CITY OF MASSILLON, OHIO
WWTP UPGRADE 2000
PIPING PLAN

ADDENDUM NO. 3

CITY OF MASSILLON, OHIO
WWTP UPGRADE 2000
TERTIARY FILTERS

SK-C28-001

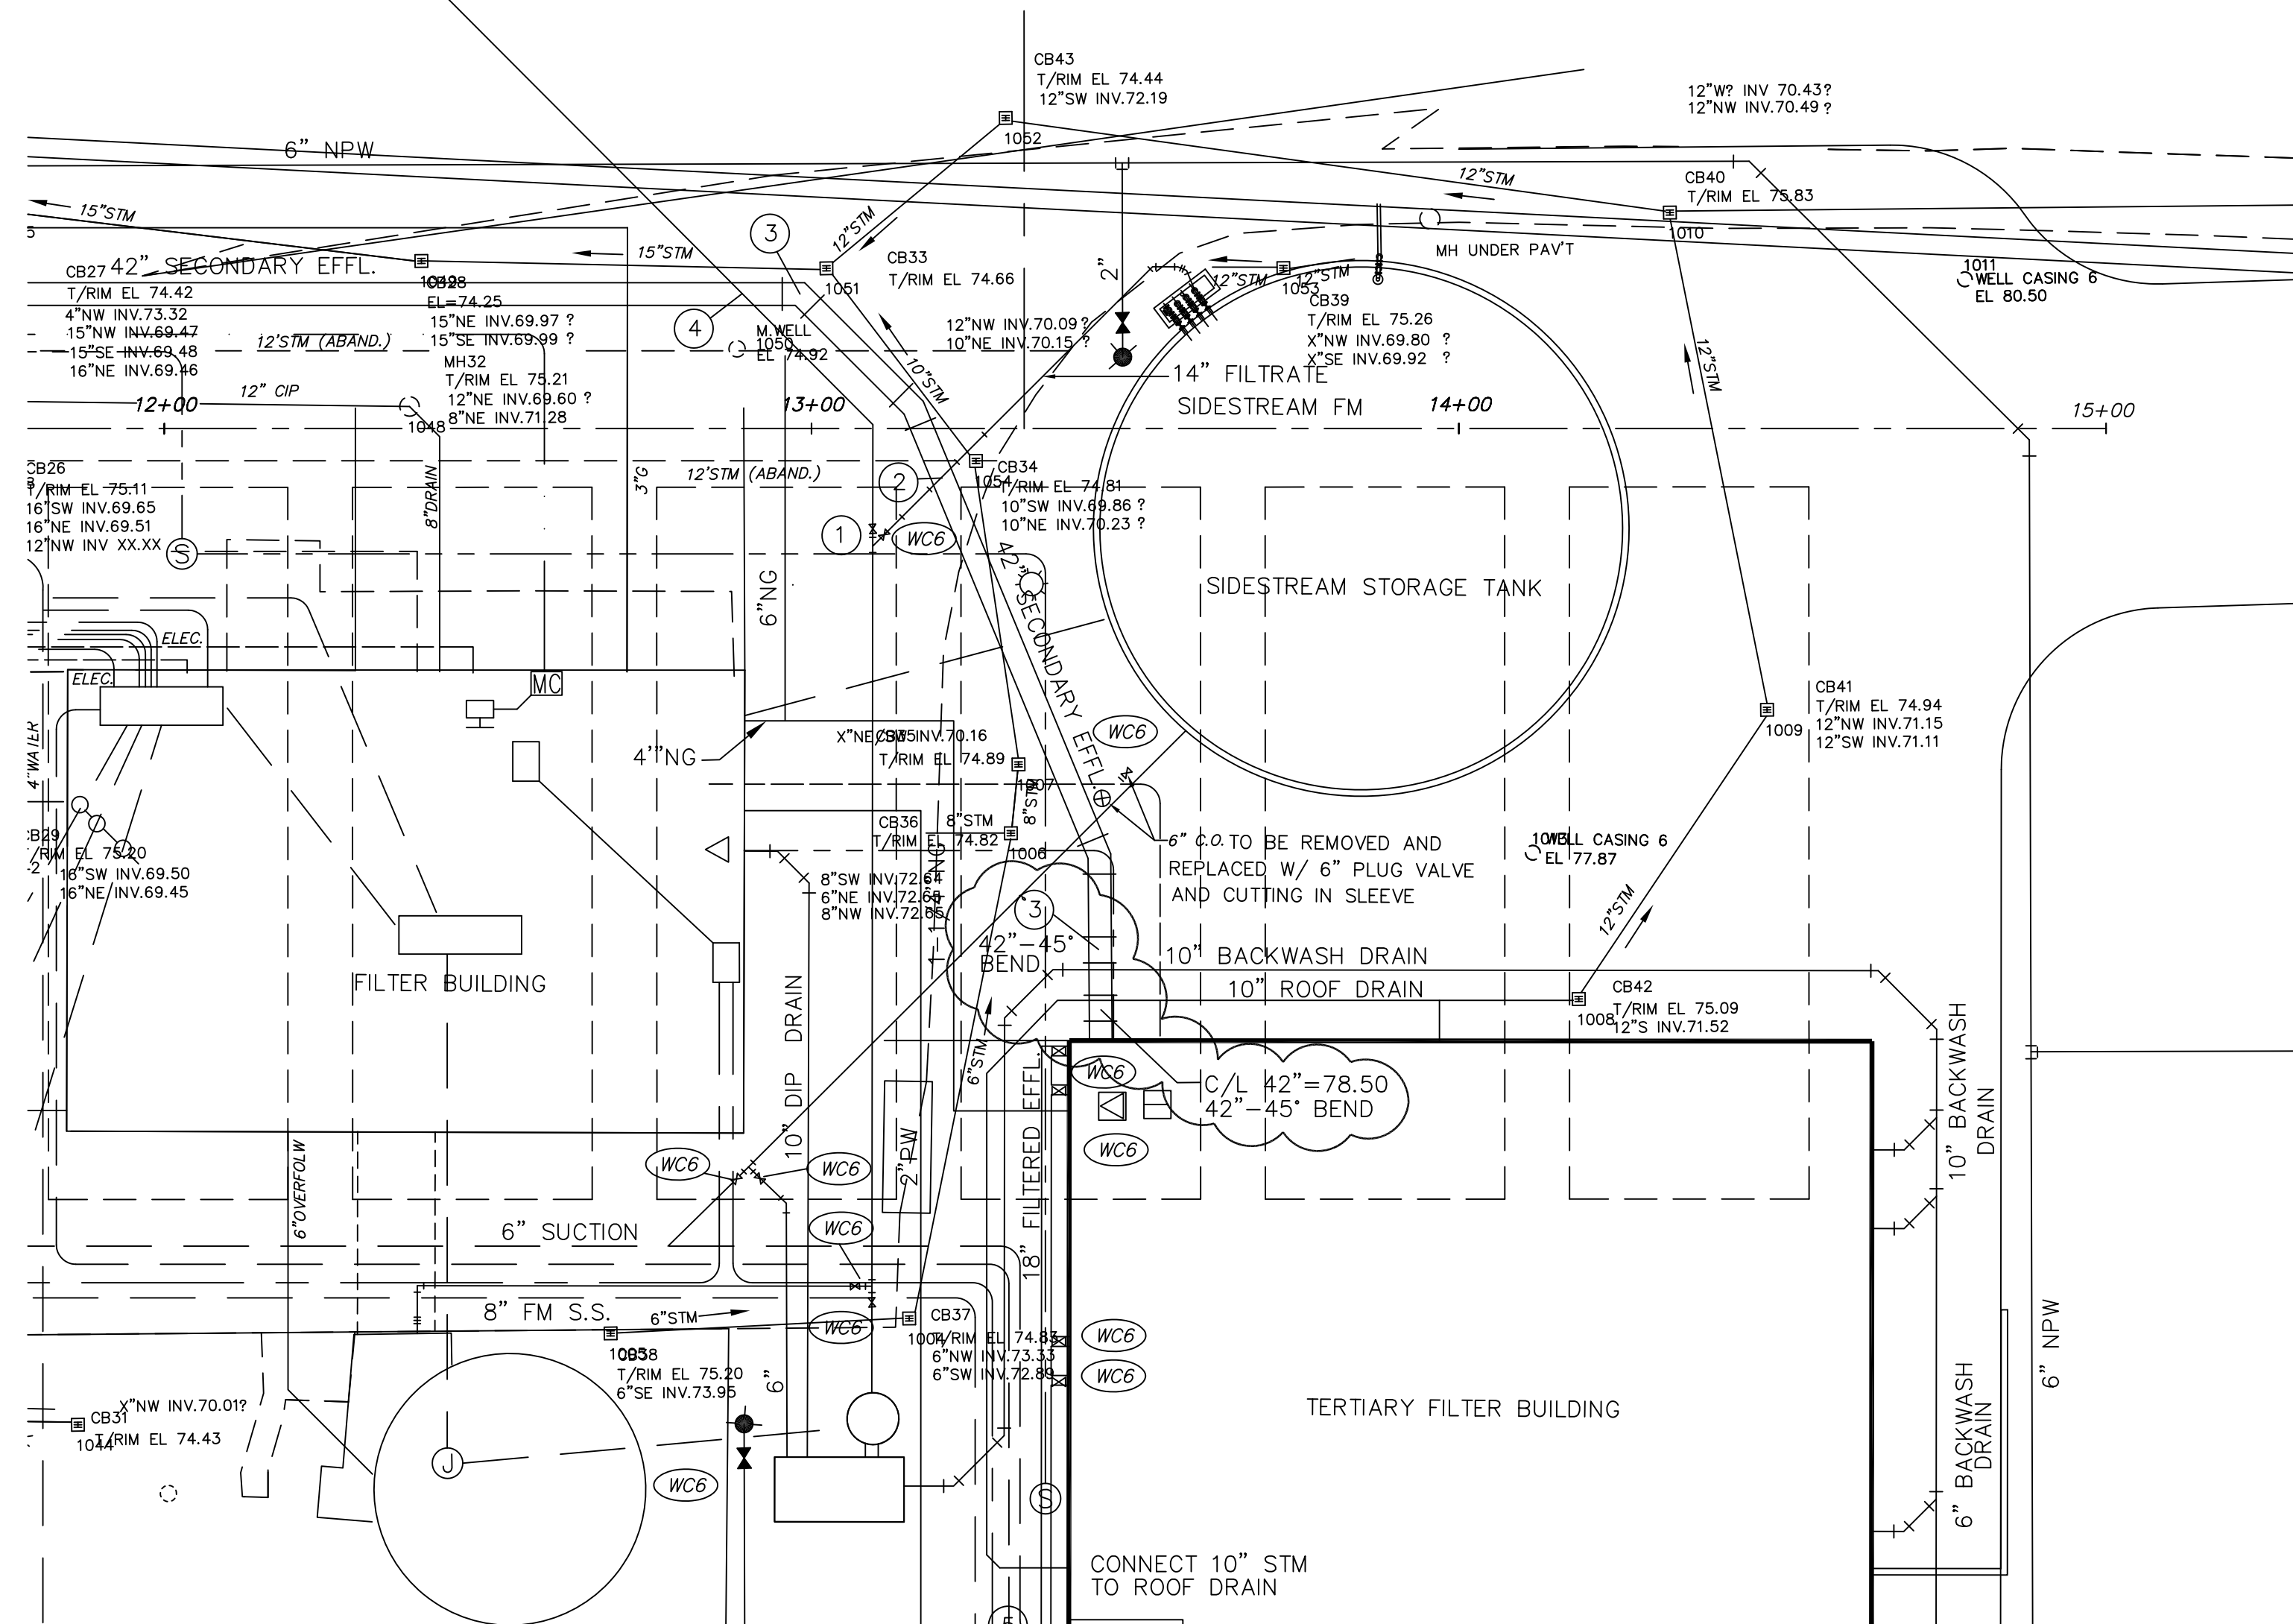
- ① C/L 14"=71.08
- ② C/L 14"=64.82
- ③ C/L 42"=69.50
- ④ C/L 42"=68.00
- ⑤ C/L 18"-90° BEND=68.00
